Product Support Bulletin 2017-001

Maintenance of Way ~ Work Equipment Bulletin

SUBJECT: HSTX Fuel Tank Mounting Ears on Main Frame

MACHINE MODEL(S): Hydraulic Switch Tamper – HSTX series

Diagram #1

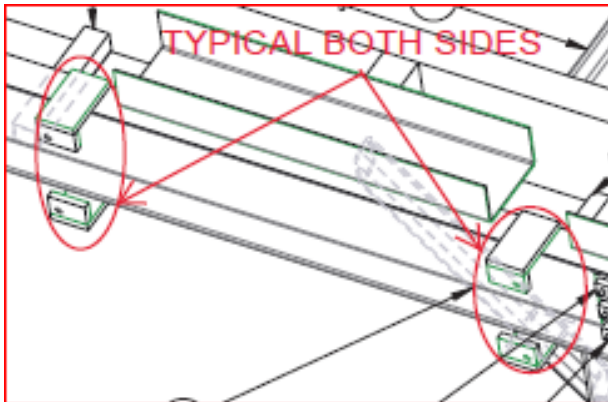
SUMMARY: In some instances the mounting brackets/ears welded to the horizontal flat bars extending off the machine frame for mounting of the fuel tank, may not have sufficient weld at the required location.

ACTION: It is required to inspect the welding on the bracket/ear for the correct specification. If weld is not correct, it will be necessary to weld the frame brackets to the correct OEM specifications. The upper and lower brackets/ears will require a full 1/4" weld on the back side where it attaches to the horizontal flat bars extending off the machine frame. This may require removing the fuel tank to gain sufficient access for inspection and repair. Any old or incorrect welds will need to be ground off and the area prepared properly for the new weld. The diagrams below will provide the correct specifications. *The installation bolt specifications are noted below as well.
